Variant name: TE0807-02-4AI21-X

# Top View

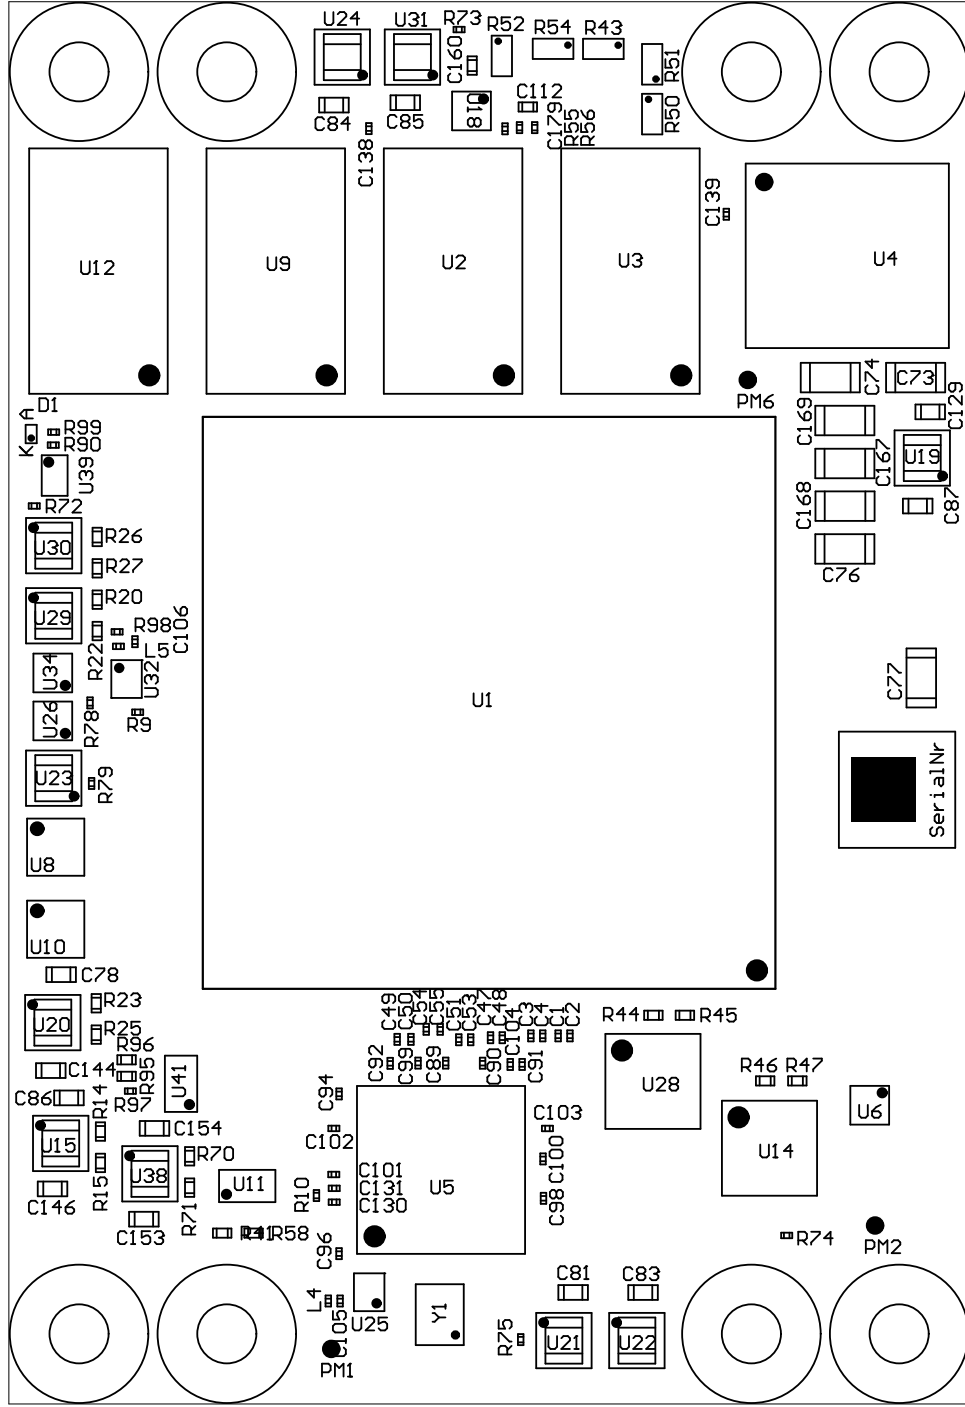
U41 Power supervisor TPS3106K33DBVR replaced by

Schottky diodes SBAS70-04LT1G
